Construction of two bridges and all associated structures, ramped walkways, stairs, lifts, boundary wall, footway and cycle paths, lighting, utilities, construction access, construction compound, hard and soft landscaping works, planting, tree removal, earthworks, drainage infrastructure, surface water drainage features and all necessary enabling works and demolitions (application ref. 23/00482/FUL)

Thank you for consulting Hinxtton Parish Council ('HPC') on the above application. The matter was considered at our meeting on 13th March 2023, and the following comments have been endorsed on behalf of HPC.

Figure 9 Future Connections to Hinxtton Village and Ickleton - this figure shows how the bridges relate to wider connections within the local area (to Hinxtton Village and Ickleton)

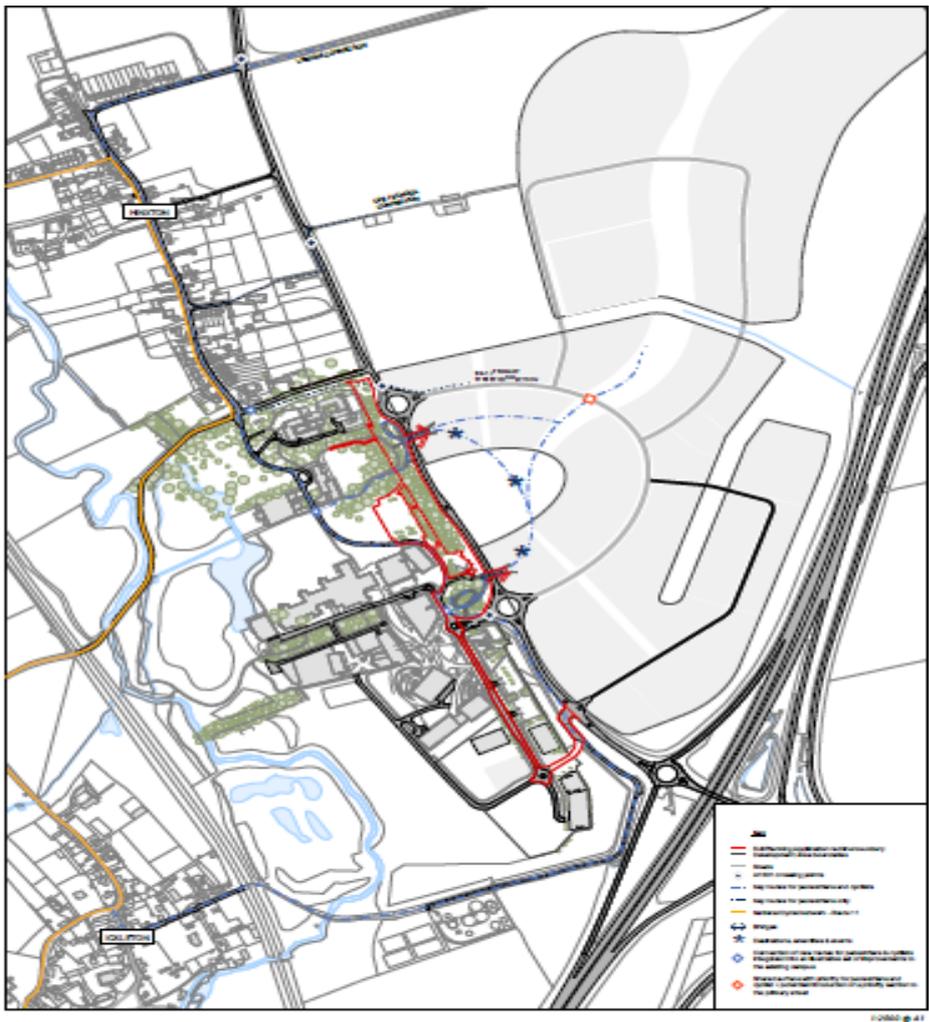
Figure 9, p25 of the DAS assumes that both cyclists and pedestrians coming from the village will use the northern bridge to cross the A1301, whereas pedestrians only will cross the road at grade.

We do not accept the Applicant's assumptions that this will be the likely movement of pedestrians and cyclists from Hinxton. We consider there is little chance that they will use the northern bridge (which the Applicant states to be 130 metres South of New Road), and will instead use the DA1 at-grade crossing at the northern roundabout (marked B above). It is so much closer.

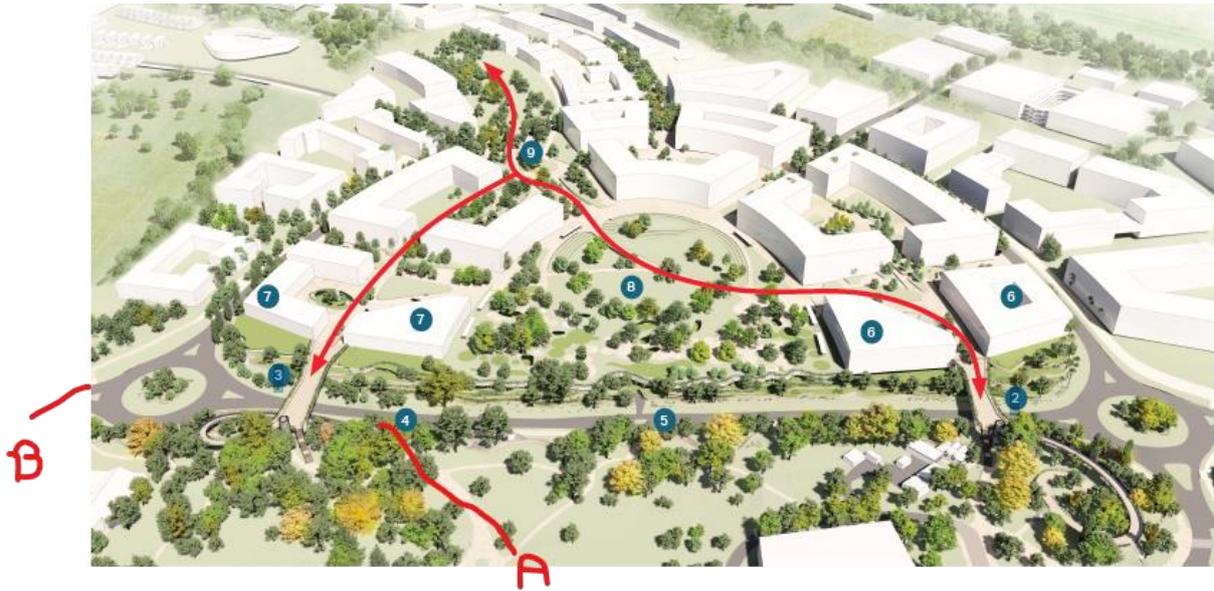
Once cyclists / ramp users from Hinxtton enter the existing campus from High Street, under the current proposals, they then need to travel past the Northerly bridge, to get on to the ramp marked A under the drawing below. The spiralling ramp gravitates away from the village and not towards it.

The DA1 crossing at the Northern roundabout is also shown more clearly in figure 32 of the DAS, page 42 (repeated below), here acknowledging the crossing to be for cyclists and pedestrians (in reality one cannot stop cyclists using it).

Table 1 of the DAS identifies the alternative options for crossing the A1301.

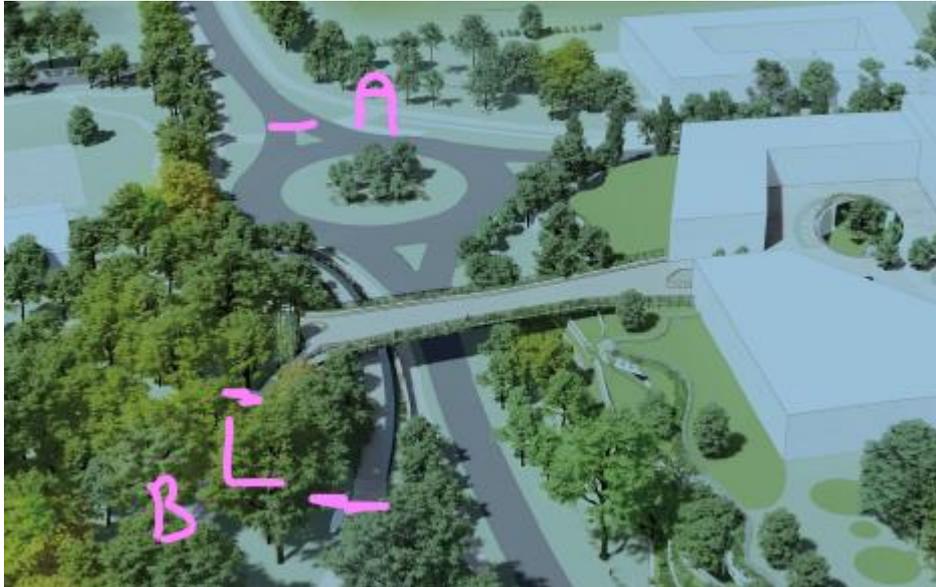
The Applicant states that a single, centrally located bridge was discounted because:

The need for a safe route to and from the primary school appears to “officially” underpin the choice of two bridges rather than one, but as noted above, we consider anyway that the school (if built) will not be accessed in this way from Hinxtton, and that the Northern footway across DA3 will be used instead. Further, the use of two bridges does not stop pedestrians and cyclists crossing the road on the DA1 crossing at the Northern roundabout. DA1 is so much quicker. See the extract from figure 40 of the DAS below, with the Northern crossing marked A and the bridge access marked B.

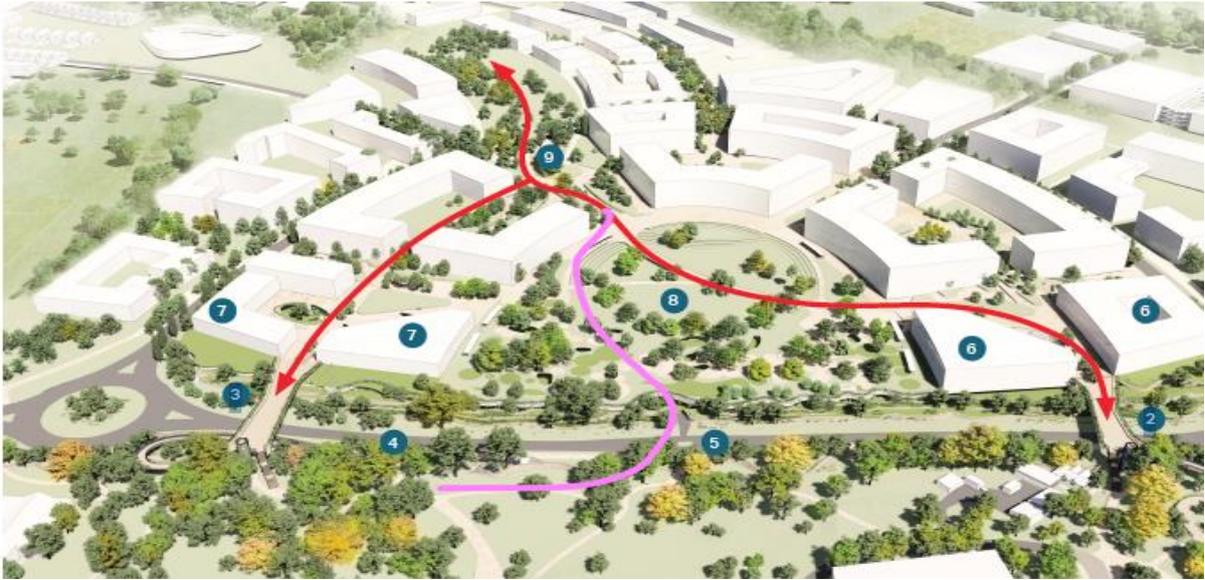
There is also a further road level crossing centrally located between the two bridges.
